Re: Concept Development Application - DA/812/2021 (PPSSCC-285)
33-43 Marion Street, Parramatta
Determination Meeting – 19 May 2022

Response to Issues – Concept Development Application – DA/812/2021
33-43 Marion Street, Parramatta

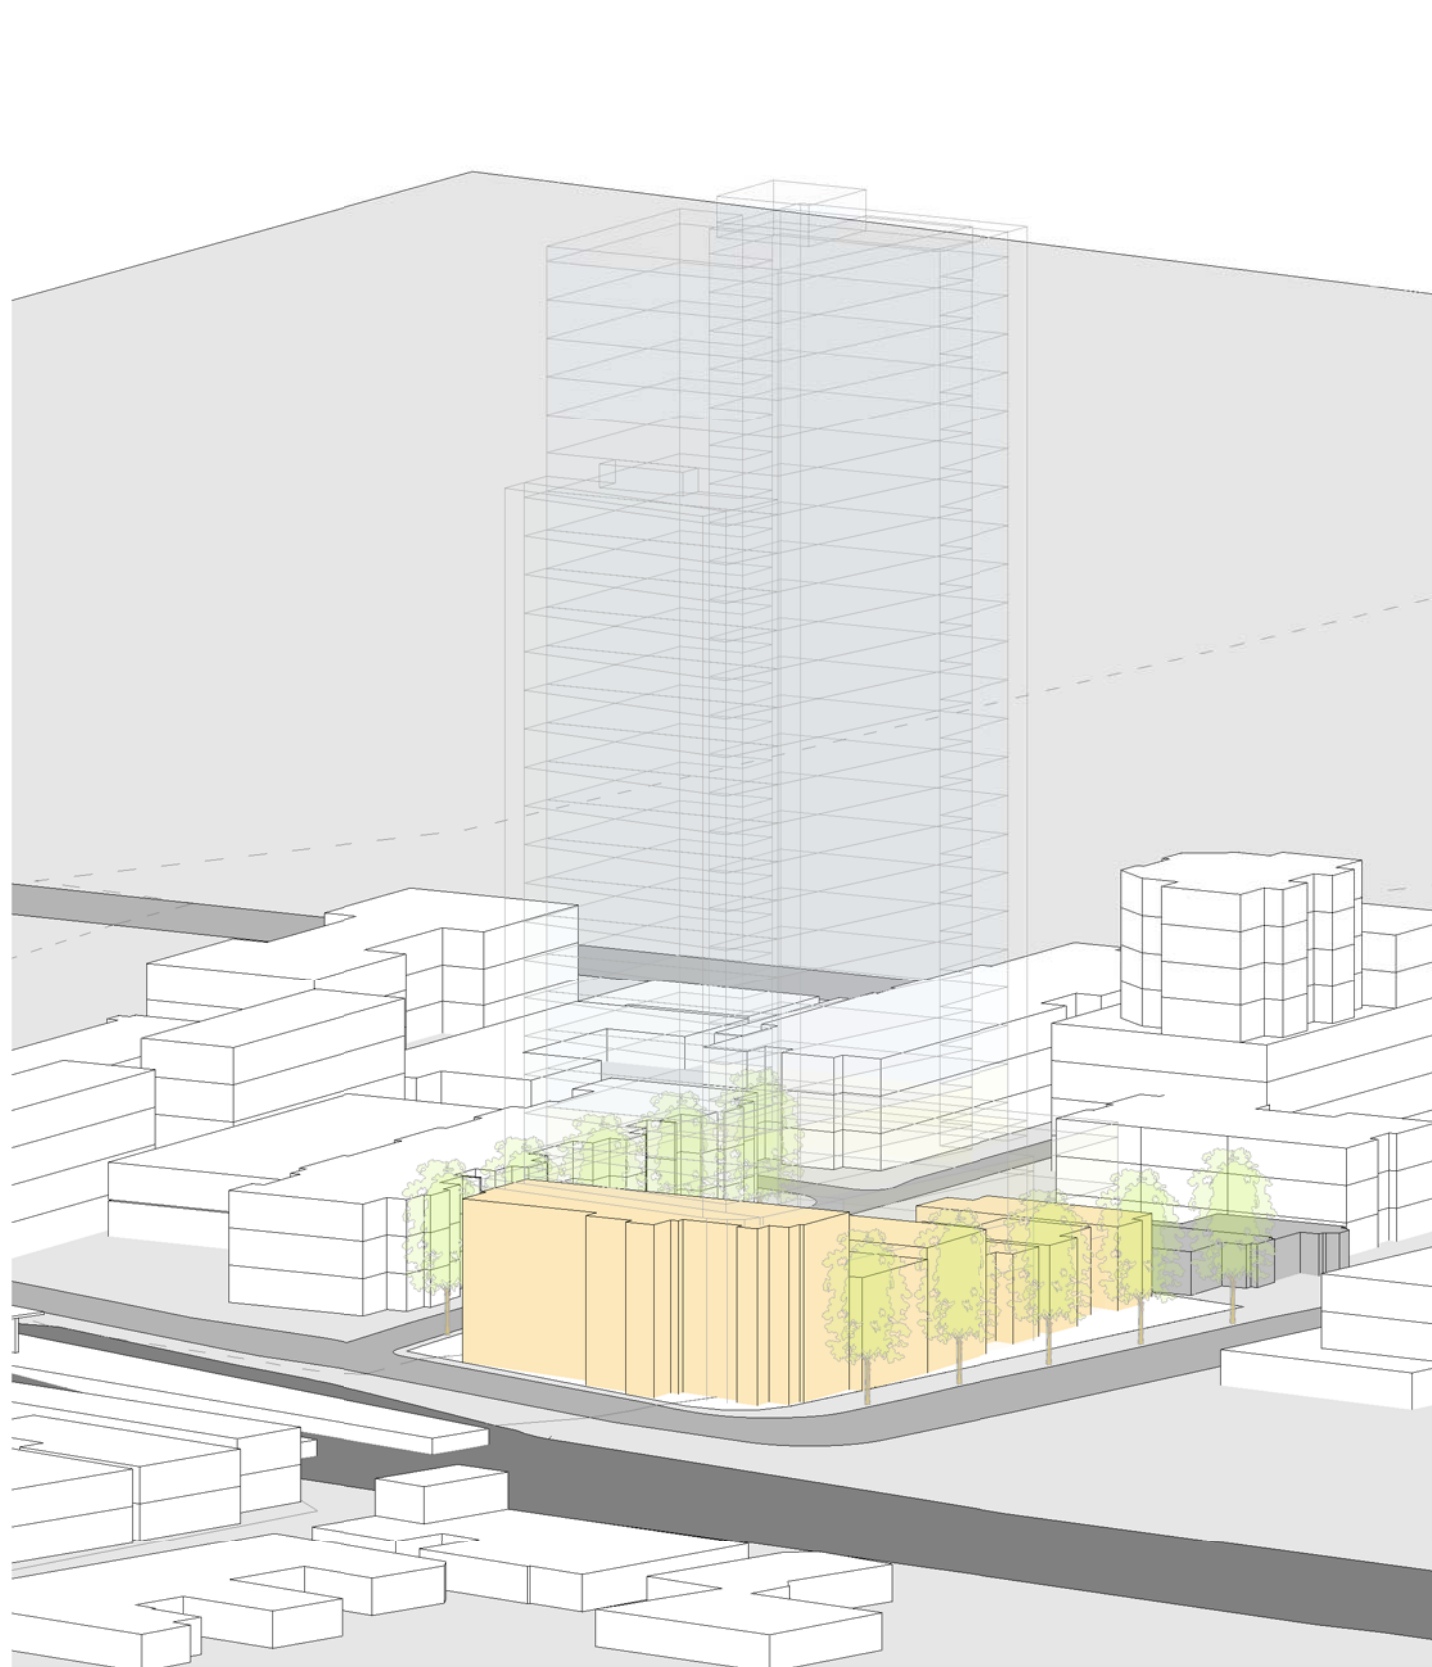
The Concept DA also proposes that the stage boundary is setback 2m from the existing boundary. This provides further flexibility for articulation and detail to this elevation to be studied during the Design Excellence Process.

Eastern elevation of Stage 1 is capable of being treated so that it has an acceptable appearance prior to the construction of the Stage 2 building. No further change is required.

project		PROPOSED MIXED USE DEVELOPMENT 33-43 MARION STREET, HARRIS PARK	
checked	FS	drawing	SOLAR ACCESS STUDY - WINTER SOLSTICE (EXISTING)
drawn	JN	issue	A
project no	19 004	drawing no	CD 410

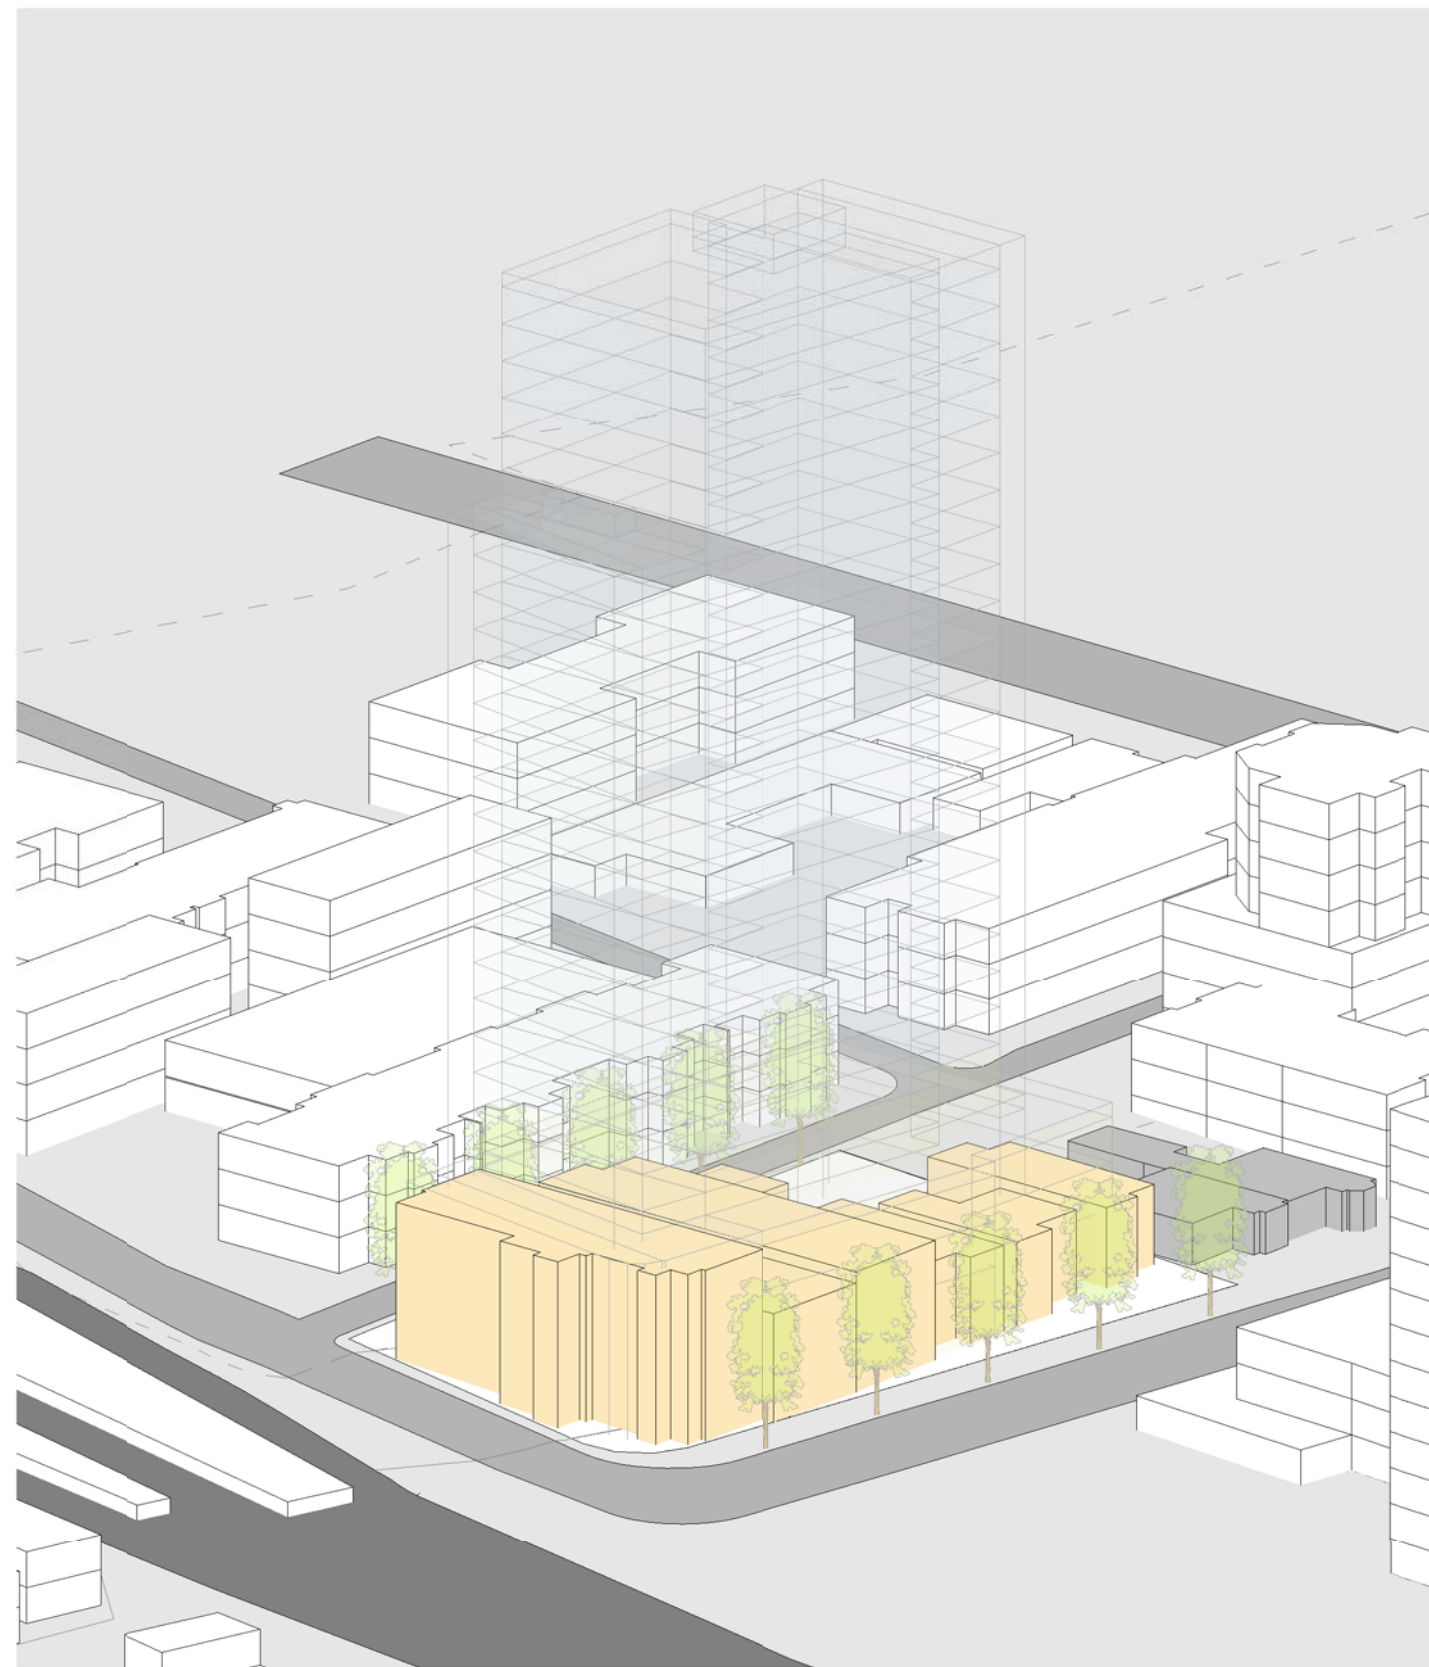
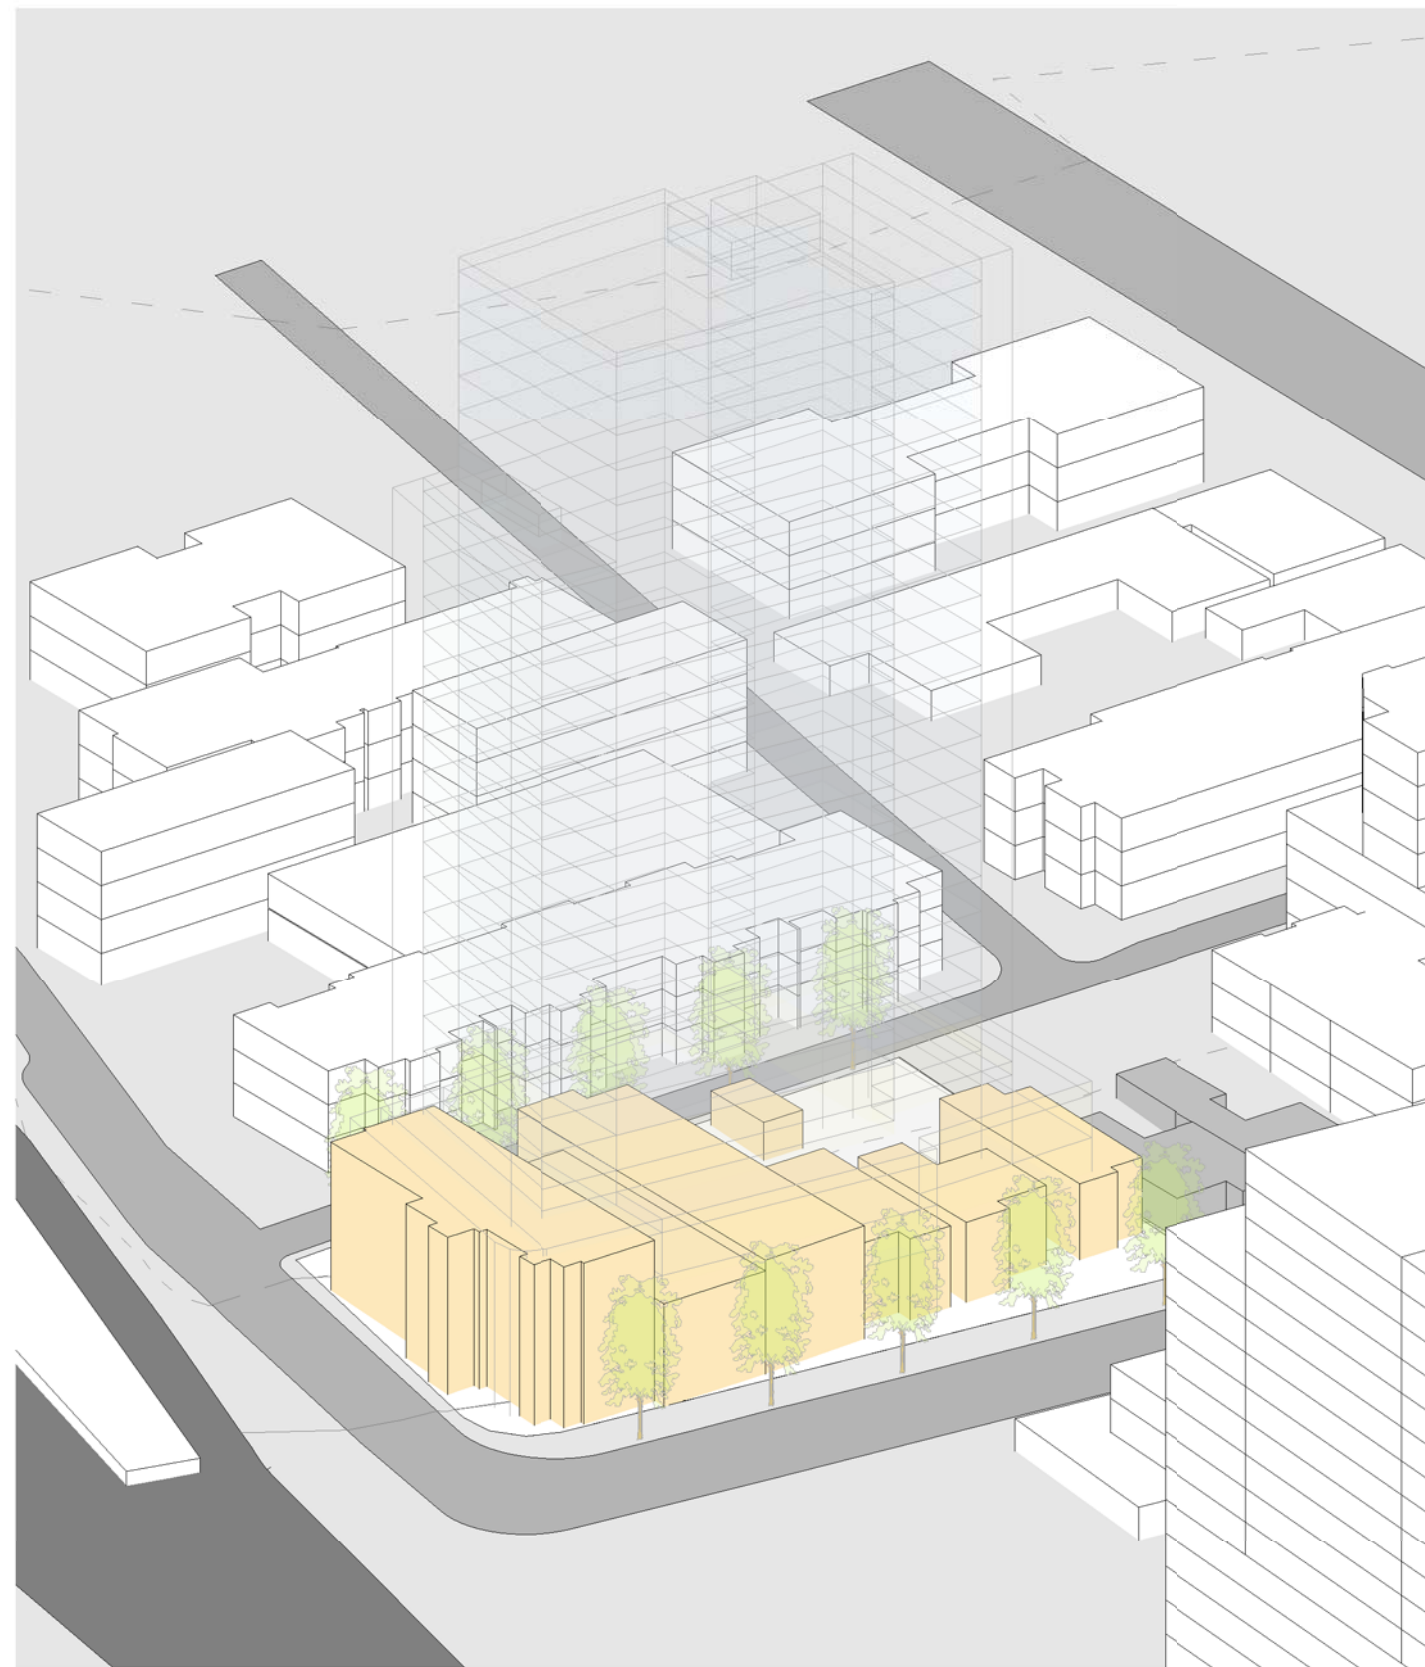
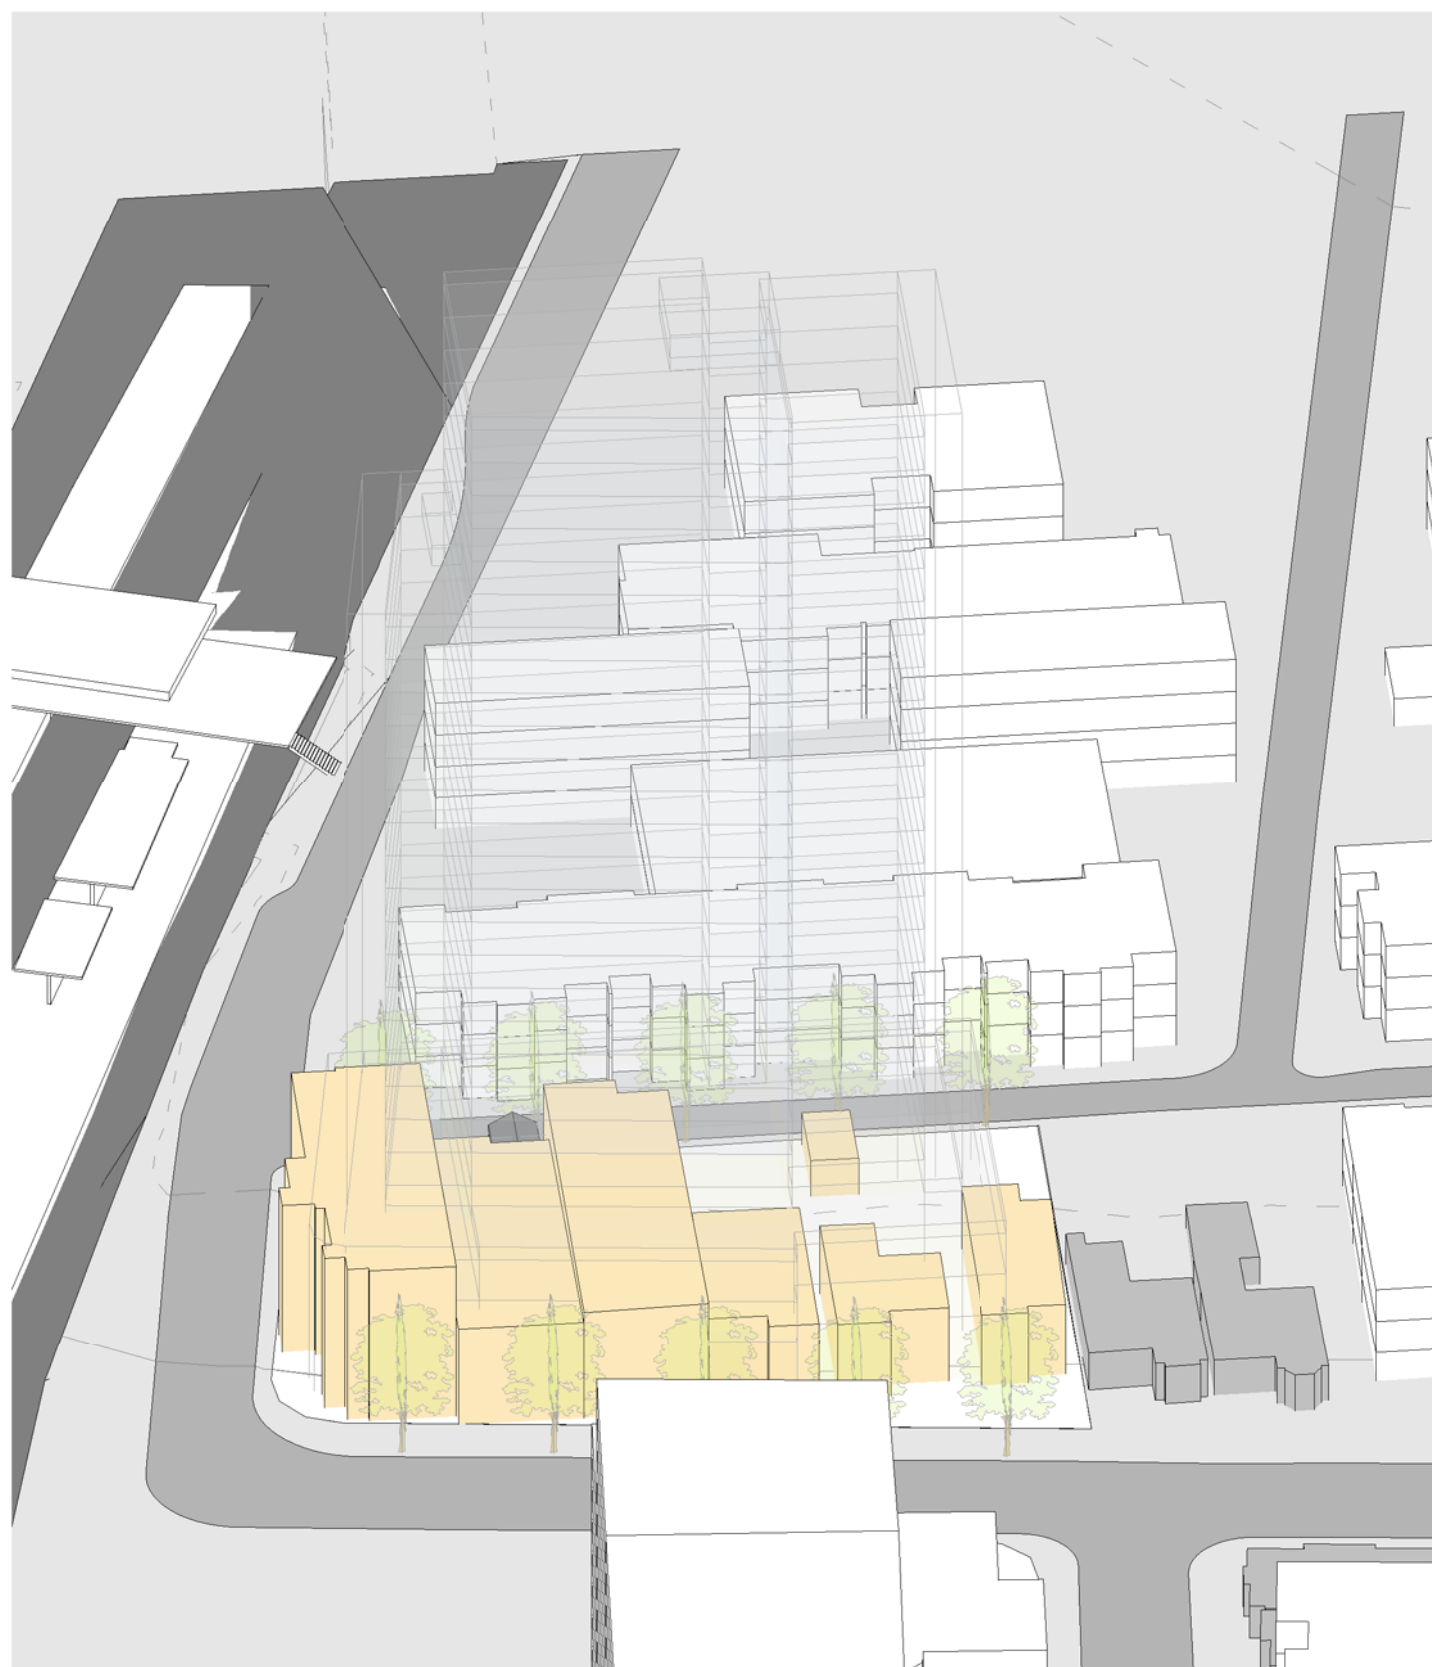
A solar access study has been prepared to assess in detail the potential impact to surrounding residential flat buildings, including 27 Station Street West and 69-71 High Street, Harris Park should the western boundary setback be reduced from 12m to 9m as proposed by the Concept Development Application.

The proposal is capable of achieving solar access to living areas and private open spaces to 70% of apartments at mid-winter and less than 15% of apartments with no solar access at mid-winter. No further change is required.
